## VILLAGE of GLENDALE

### Village Gate Traffic Impact

To: Loretta Rokey, Village of Glendale  
From: Andrea Harth, P.E.  
Date: 6/10/15  
Re: Village Gate TIS Review

**TRAFFIC IMPACT STUDY  
FOR  
VILLAGE GATE**

Figure 6

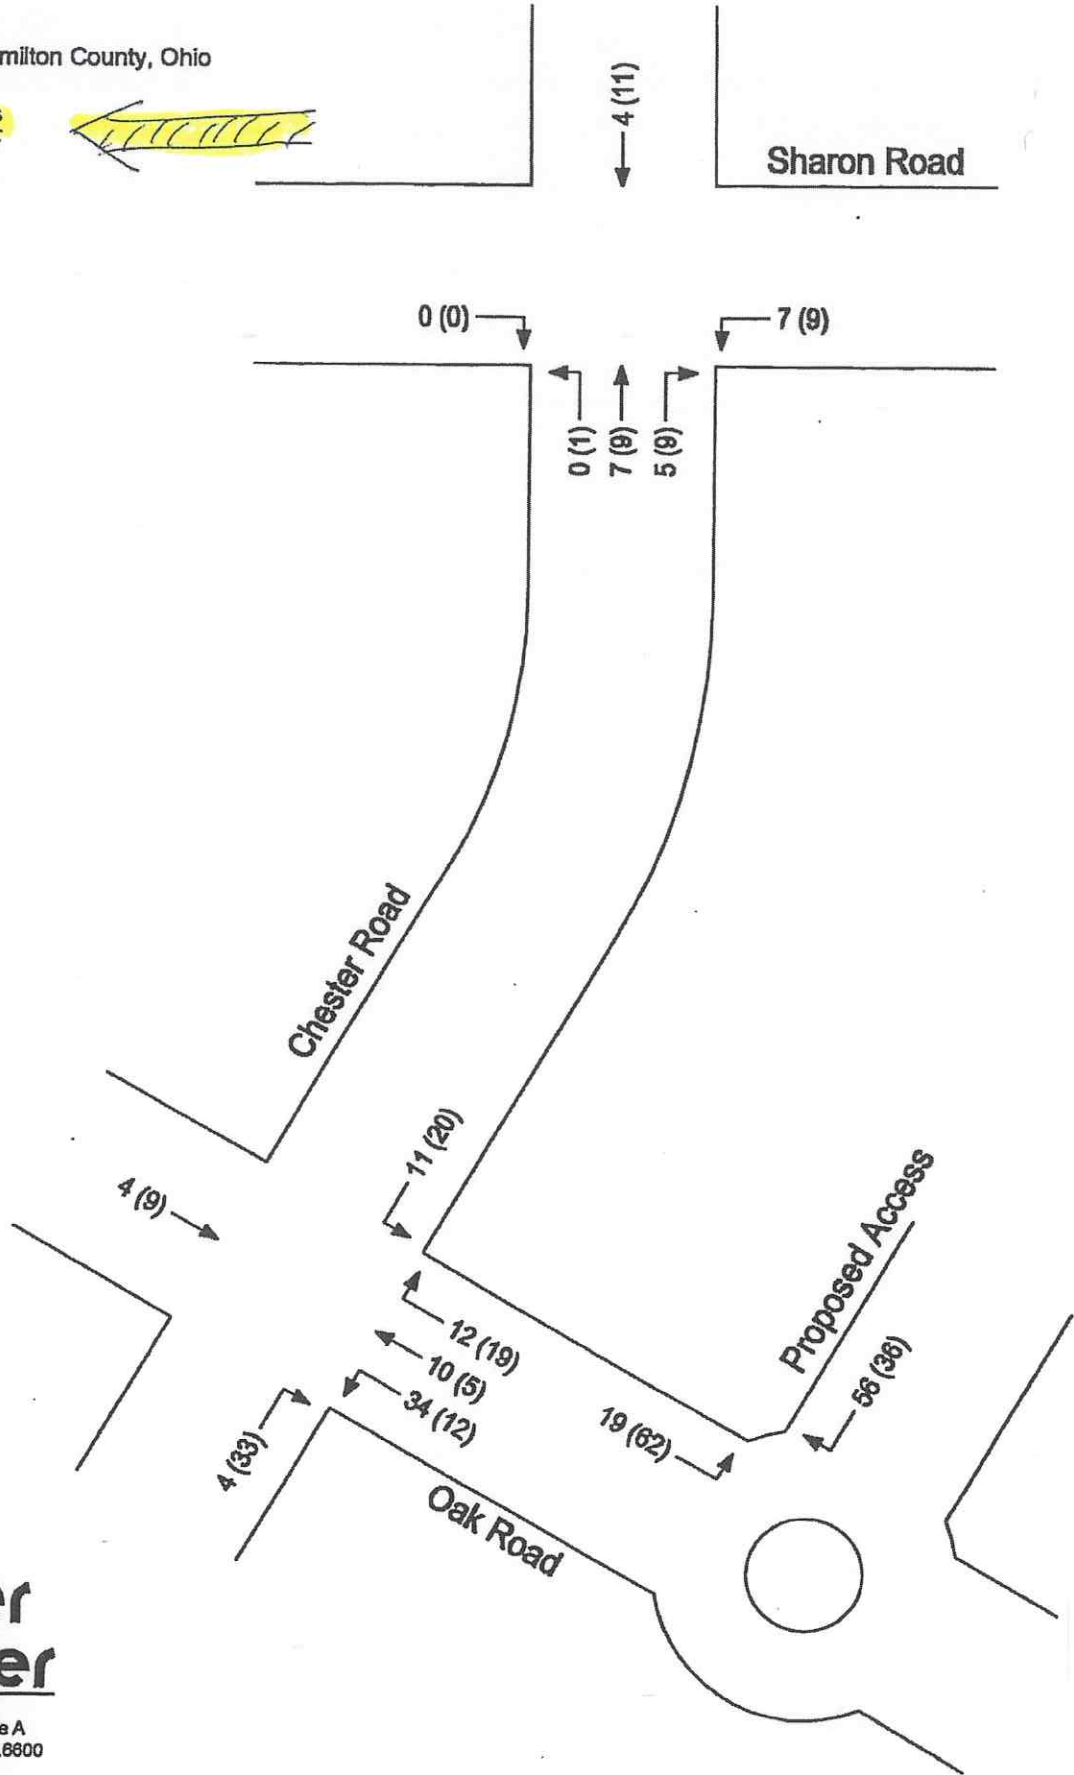
a. Trips show entering and exiting in opposite directions for each peak.

- i. AM Peak- 60% enter from the north, and 22% exit to the north. 22% enter from the south, 60% exit to the south
- ii. PM Peak- 32% enter from the north, 53% exit to the north. 53% enter from the south and 32% exit to the south.

Typically, trips would enter and exit to the same direction, usually towards a major thoroughfare. The trips appear to be based on the existing distribution along Chester, which are heavier in the morning. These trips are likely trips from the north to the commercial/industrial area.

- b. The percentage of thru vehicles for westbound Oak Road seems high. We would assume 5-10%.
- c. The percentage of northbound thru vehicles seems high at Sharon and Chester. We would assume most trips would be towards the interstate.
